E5071B-14

S E R V I C E N O T E

E5071B ENA Series Network Analyzer, 300 kHz to 8.5 GHz

Firmware update is failed with CP300 HDD image, while updating firmware to FW Rev.A.08.00 or later

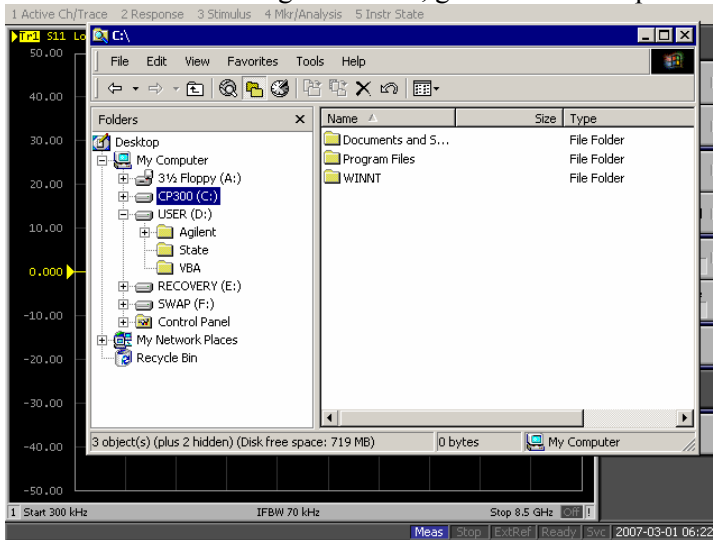
Step1. Check whether the HDD image revision is CP300 or not.

If the HDD image is CP300, go to the next step.

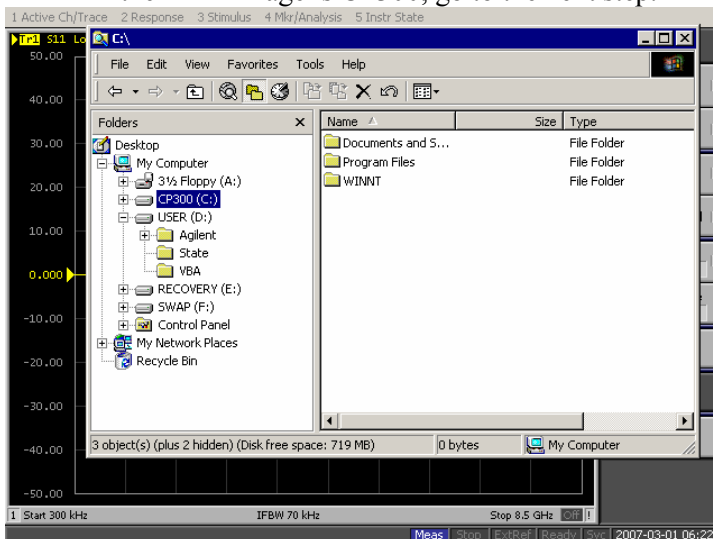
Step3. Check whether the customer intends to update the firmware to FW Rev.A.08.00 or later.

If yes, replace the A27 HDD referring to the E5070B/E5071B service manual chapter 5, 6 & 7.

If no, perform System Recovery referring to the E5070B/E5071B service manual chapter B.
